SP121-4, Curb and Gutter Mountable 02/16/22

Proposed Revision To: <input type="checkbox"/> Standard Specifications For Public Works Construction <input checked="" type="checkbox"/> Standard Plans For Public Works Construction	Change No. 319 SP <small>(ASSIGNED BY GREENBOOK COMMITTEE)</small>
Public Works Standards, Inc. AGC Southern California Regional Office 1255 Corporate Center Dr., Suite #100 Monterey Park, California 91754	Date Proposal Received <div style="border: 1px solid red; padding: 5px; color: red; text-align: center;">02/16/2022</div> <small>(ASSIGNED BY GREENBOOK COMMITTEE)</small>
Subsection or plan to be revised: SP121-4, Curb and Gutter - Mountable On page(s):	
Revision: Add plans for rolled curb and for 'flared' low curb-face curb and gutter.	
Reason For Revision: Provide more options for user agencies.	
Submitted By: <u>David Mitchell</u> Phone No: <u>(562)400-9159</u> Agency: <u>Member At Large</u> Address: _____	
Instructions: Use a separate form for each revision. Use plain paper attached to this form if more space is needed. For minor changes, copy present wording using strike-over with dashes for words to be deleted and underline new text. For major changes

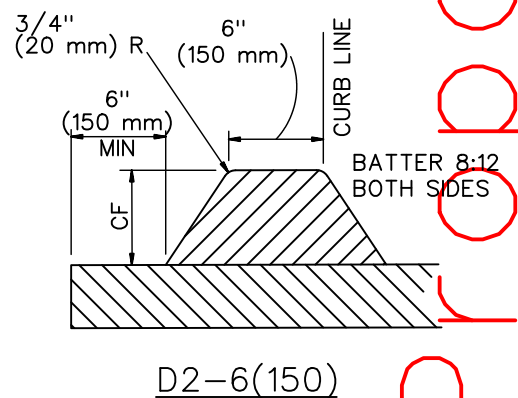
Swapped
